ADDENDUM #01

TO CONTRACT DOCUMENTS FOR: PROJECT #CP250051 – Agriculture Engineering Building – Rms 164/166 Fermentation Lab Renovation

PREPARED FOR: The Curators of the University of Missouri

CONSULTANT: Planning, Design & Construction
University of Missouri
130 General Services Building
(573) 882-6800

**LEVEL 01 & 02 PLANS
PIPING**

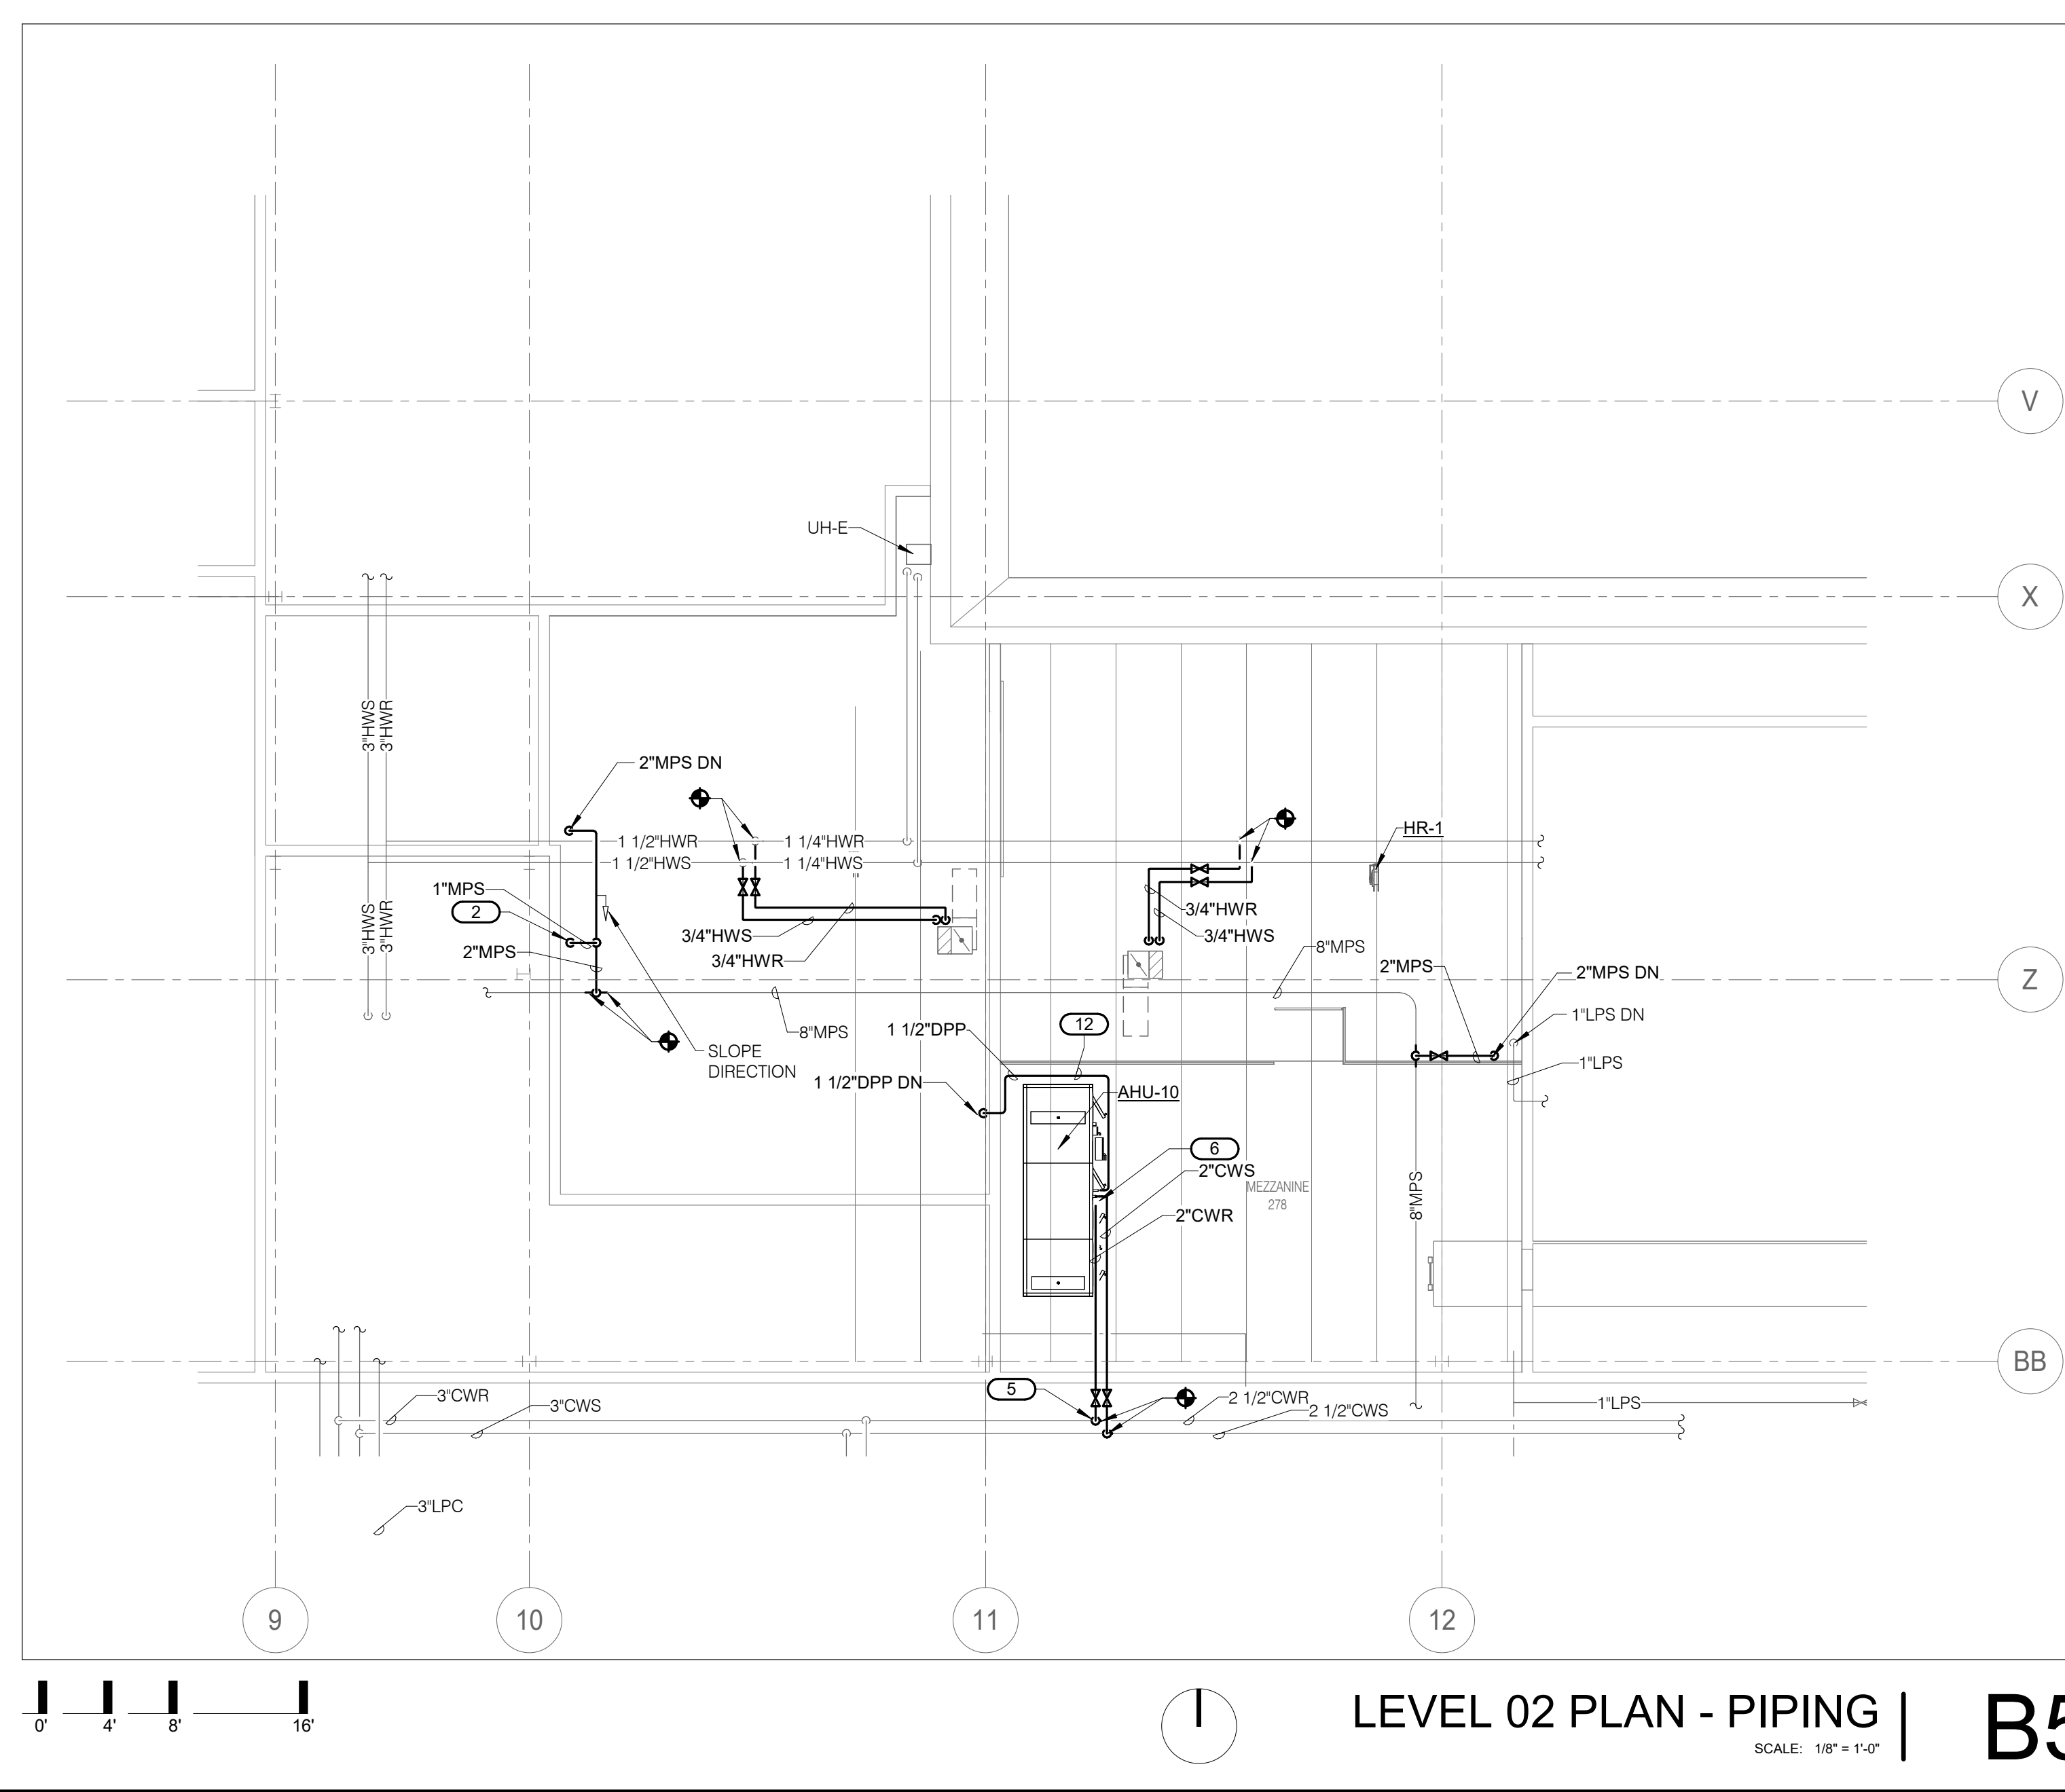
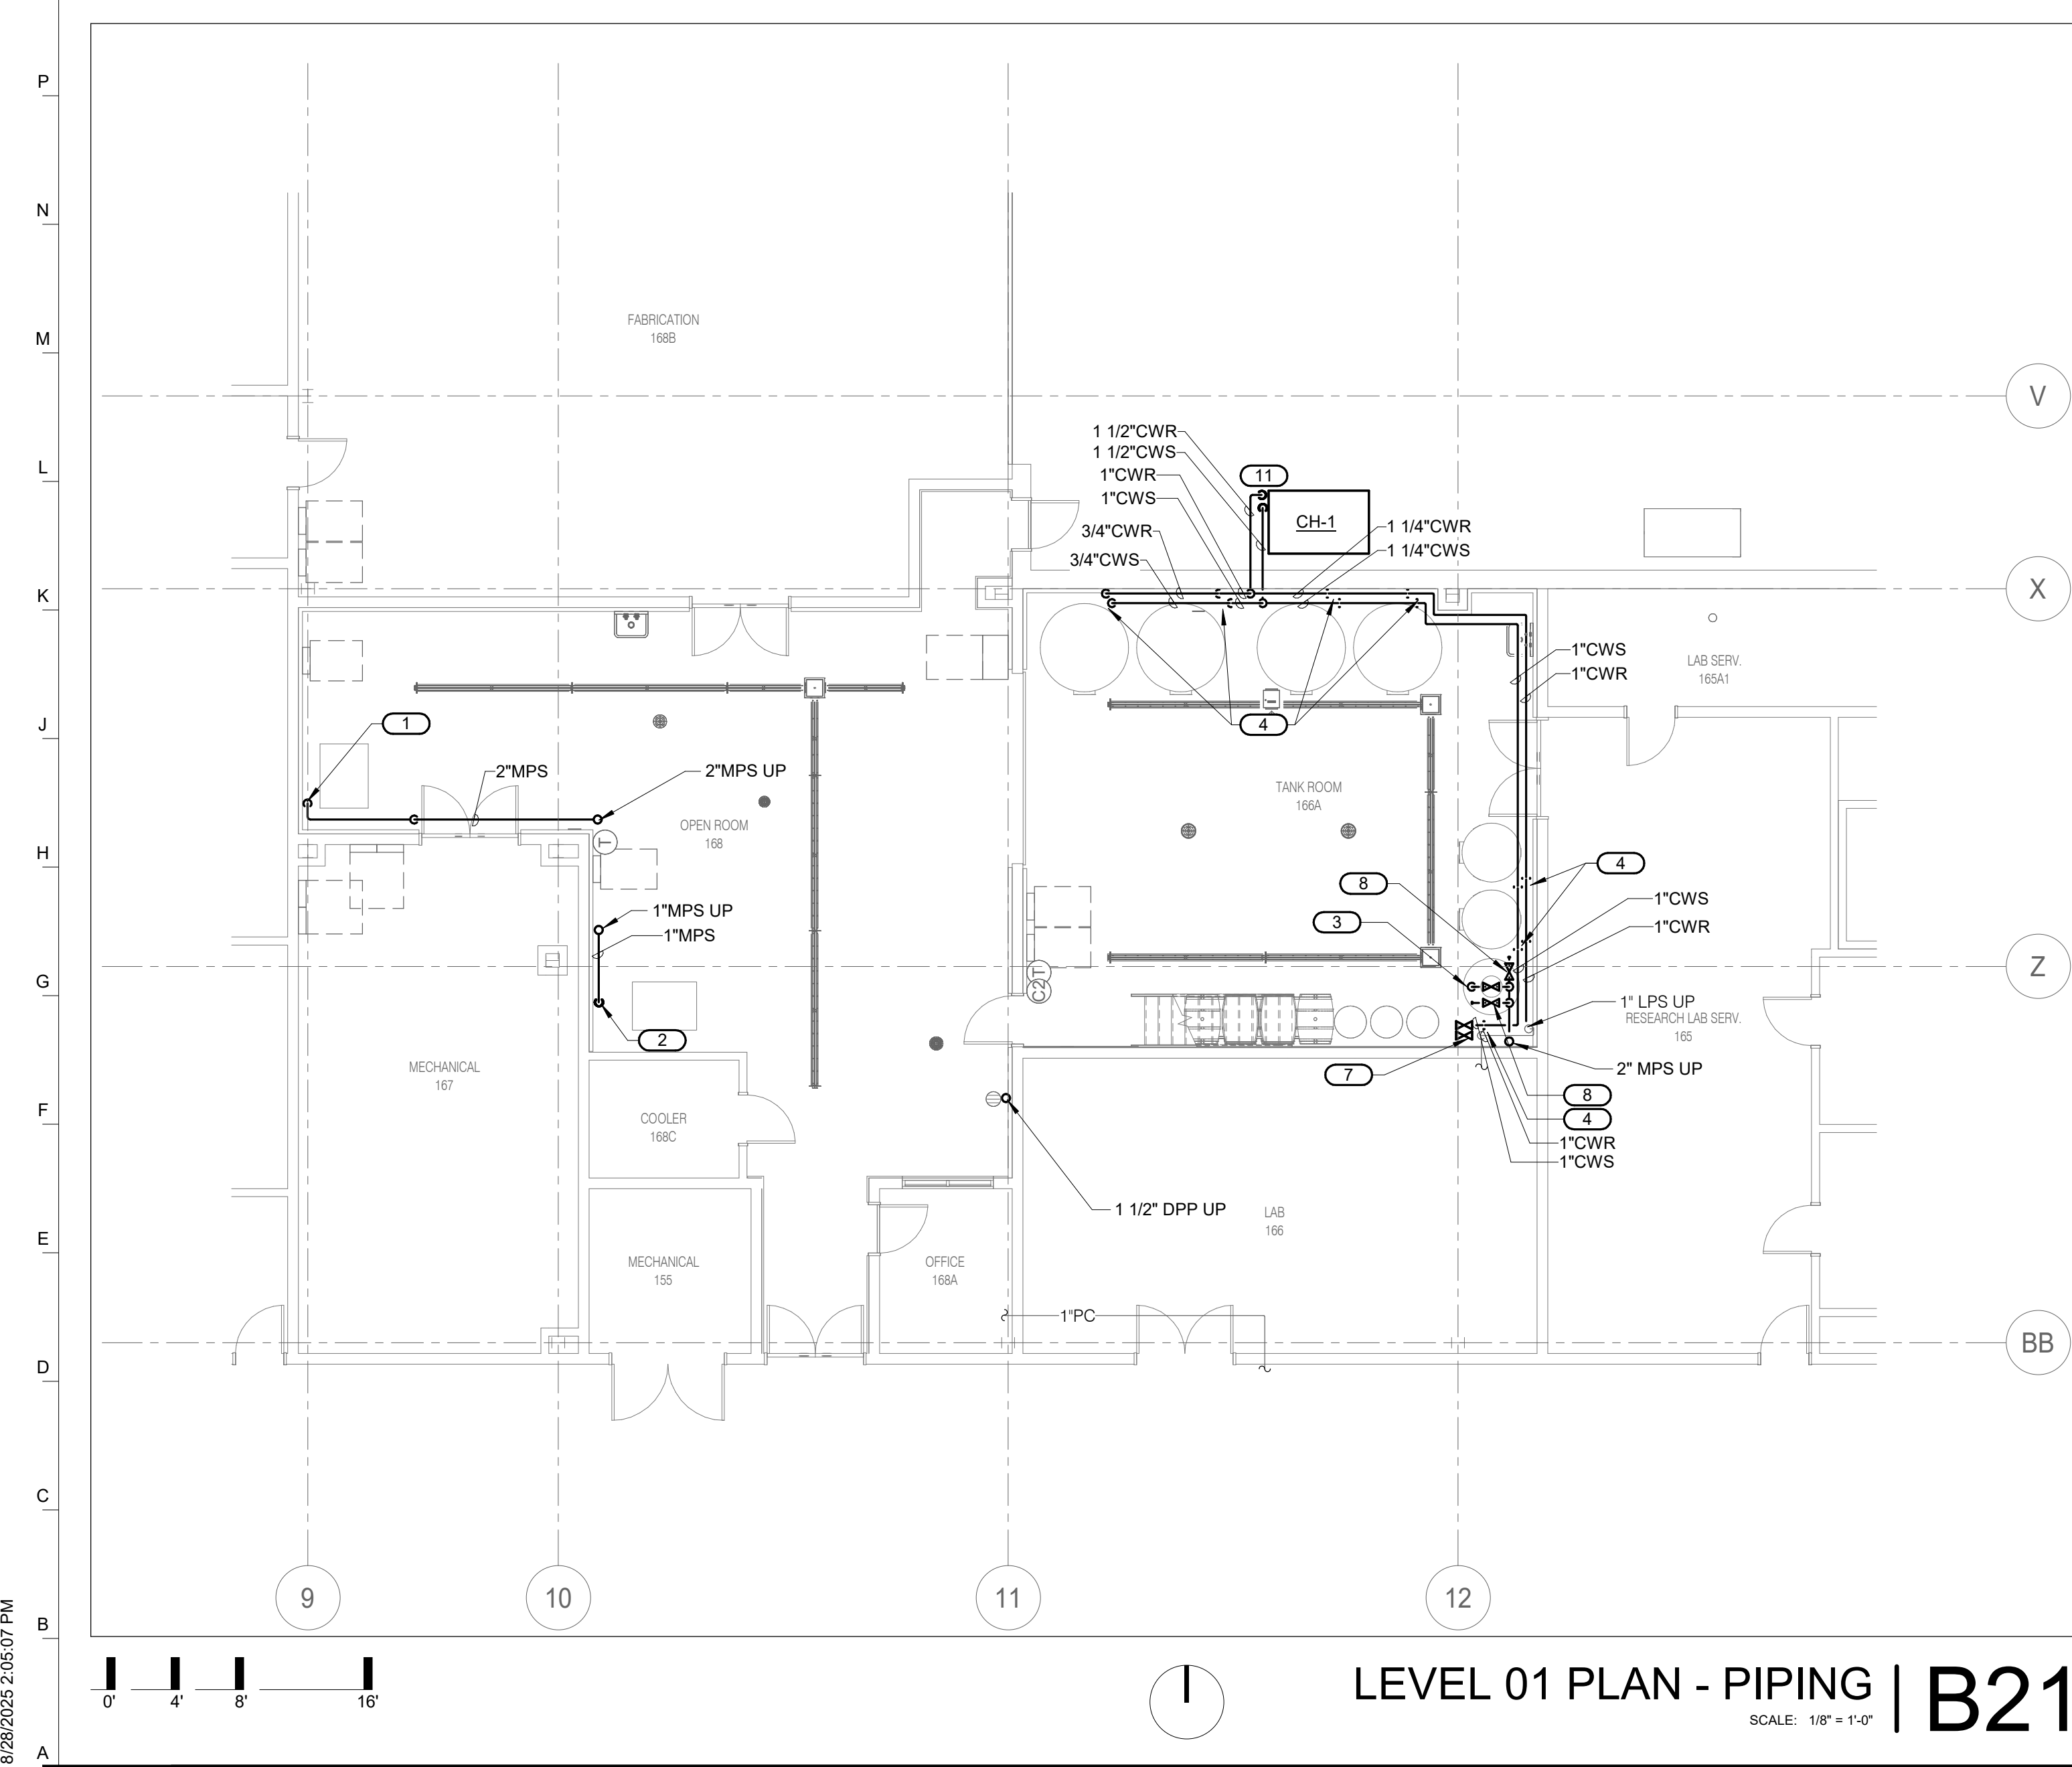
CLARIFICATION: Keynote 4 revised for contractor to coordinate with owner on flexible piping requirements.
Keynote 5 revised to indicate piping connections to be above accessible ceiling.
New Keynote 13.
Demo Unit Heater equipment and note added in Room 168.
